Change Order, Construction Manager as Adviser Edition

Christian County High School

Change Order Number: 092

Project:	Christian County High School 5185 Ft. Campbell Blvd Hopkinsville, KY 42240	PR No.:	058
Owner:	Christian County Public Schools 222 Glass Ave Hopkinsville, KY 42240	Date:	September 2, 2025
To:	Kevin Hitchell Alliance Corporation 116 E. College Steet Glasgow, KY 42141	Project Number:	2106-204
RE:	Area J & G Modifications	Contract for:

FIRST FLOOR PLAN - AREA G

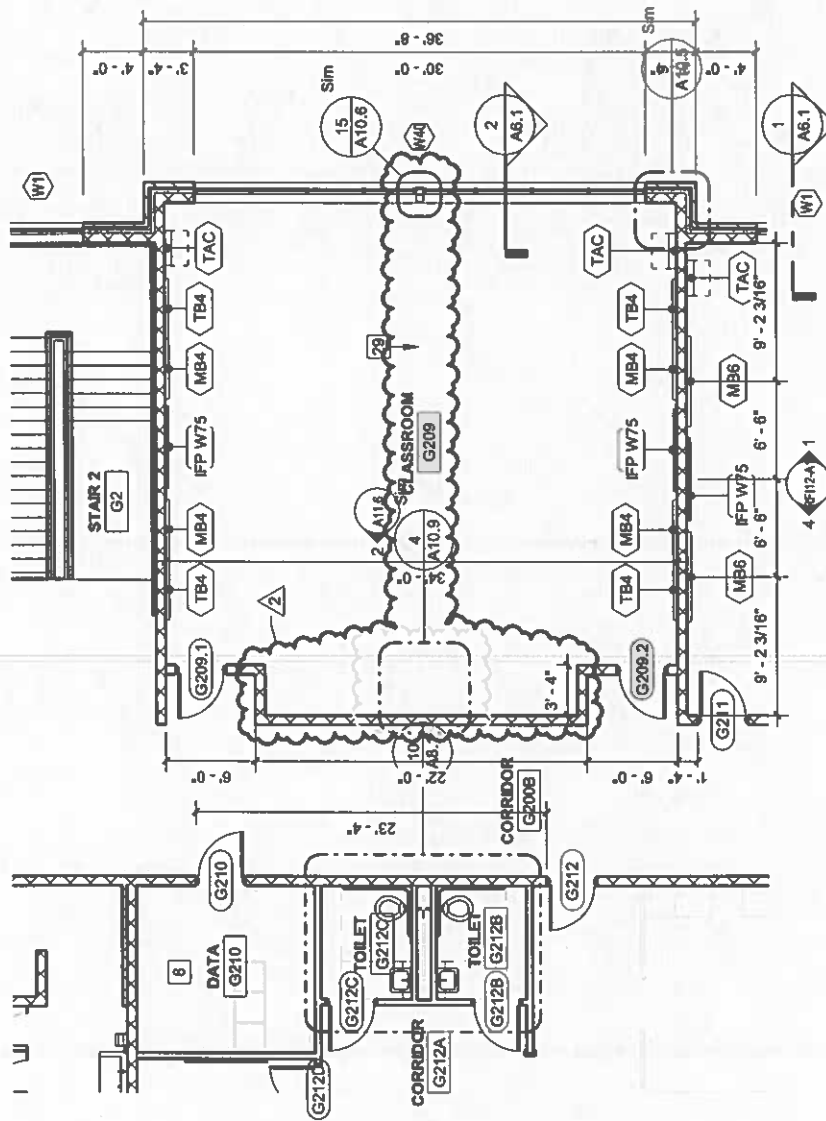
- b. Classroom G112. Changed power feed to receptacles within furniture system to receptacles installed within the wall.
 - c. Classroom G118. Changed power feed to receptacles within furniture system to receptacles installed within the wall.

- d. Added note G64.
- 6) Reference revised drawing E2.1H Rev. 5:
 - a. Construction Instruction J102. Changed power feed to receptacles within furniture system to receptacles installed within the wall.

SECOND FLOOR PLAN - AREA G

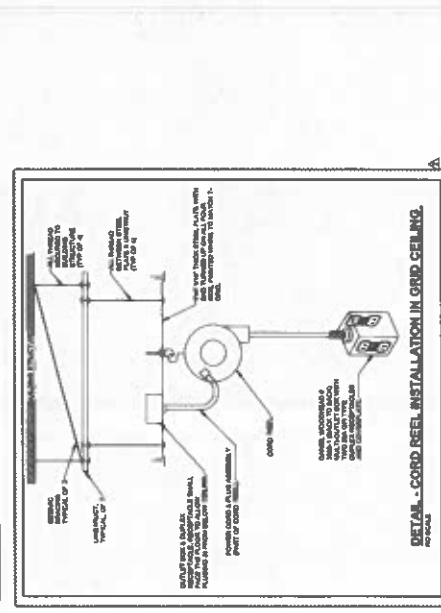
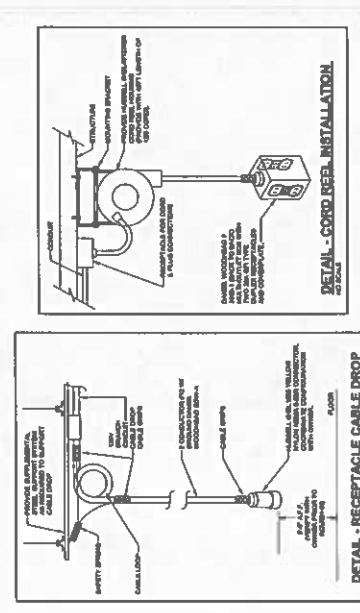
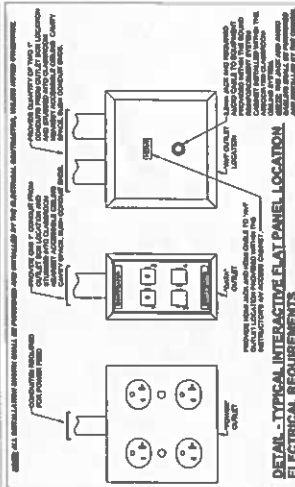
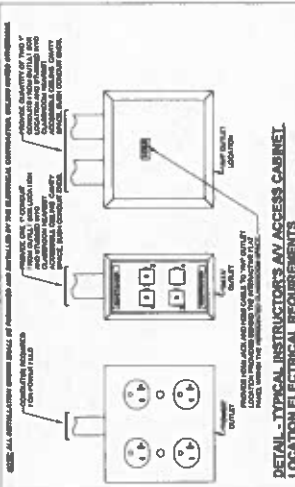
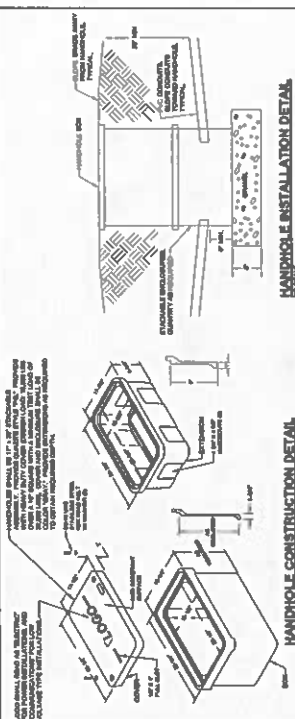
- 8) Reference revised drawings E2.2G Rev. 4 & E6.10 Rev 5\;
 - a. Classroom G206:
 - i. Deleted power feeds from two type 2B poke-thru devices to the receptacles within furniture system.

- ii. Deleted power circuits (qty 6) to the two type 2B poke-thru devices. (Note: These circuits will be reused to feed the new poke-thru device locations within Graphic Design room 208).

- iii. Deleted two type 2B poke-thru devices. (Note: If the poke-thru devices have been installed, then Blank cover plates shall be provided.
 - b. Graphic Design room G208:

- i. Added a quantity of eight type 2C poke-thru devices.
 - ii. Added a quantity of two 120V, 20A branch circuits and reworked a quantity of 6 120V, 20A power feeds to the new poke-thru devices.

- iii. Added circuits from the eight new poke-thru devices to the furniture system raceways.
 - c. Deleted note G32.
 - d. Added notes G34 & G35.
 - e. Classroom G209. Removed receptacles from four locations and converted the outlet boxes to furniture system power raceway feeds. The two circuits which feed the furniture system power raceways shall be the same two circuits which feed the receptacles on the same wall as the furniture system..
